SERVICE BULLETIN
SB1621

ADDRESSEES	: Owners and operators of coaches listed under “Application” ABC Customer Care and Parts Source
VEHICLE MODEL	: CX.., TX.., TDX25US
MANUAL CHAPTER	: 10.62 Body and accessories – Passenger seats
BULLETIN TYPE	: Field change program
DATE	: November 19th, 2019
SUBJECT	: **To check fastening of passenger seat foot rests**
TERMS & CONDITIONS	: Refer to the warranty section further in this bulletin.

Figure 1: Right weld securing footrest bracket to seat frame

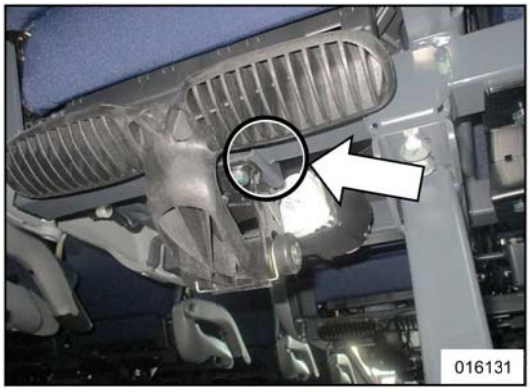
Van Hool has been informed by KIEL, manufacturer of passenger seats, about a possible problem on some vehicles with the fastening of the footrest bracket to the passenger seat frame. The issue is explained by poorly executed welds (due to an error in a welding process change at KIEL).

This bulletin has been released to assist in checking/improving the footrest bracket fastening.

From unit 81522 onwards, the passenger seats are manufactured according to an improved welding process.

Figure 3

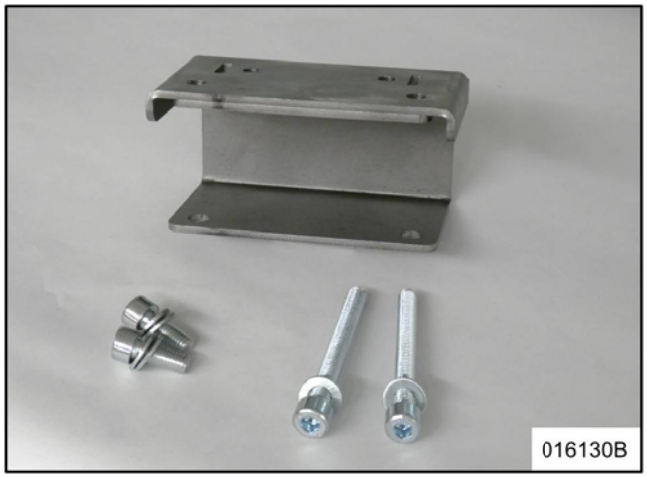
Components of retrofit kit VH11706660

Step	Action
1.1	Remove the seat cushion.
1.2	Remove the footrest from the bracket.
1.3	If necessary, push the existing footrest bracket back home and machine the bracket edges to make sure the "screw-on bracket" fits further on.
1.4	Slide the "screw-on bracket" over the existing footrest bracket. Secure the bracket by using the two long screws from the kit. Provide each screw with a washer at the screw head side. Tightening torque screws: 25 Nm (18 ft.lbf).  **Figure 5**

1.5	Reinstall the footrest by using the two short screws from the kit. Provide each screw with a **double** washer at the screw head side to prevent the screw end from touching the seat frame . Tightening torque screws: 25 Nm (18 ft.lbf).
1.6	Reinstall the seat cushion.
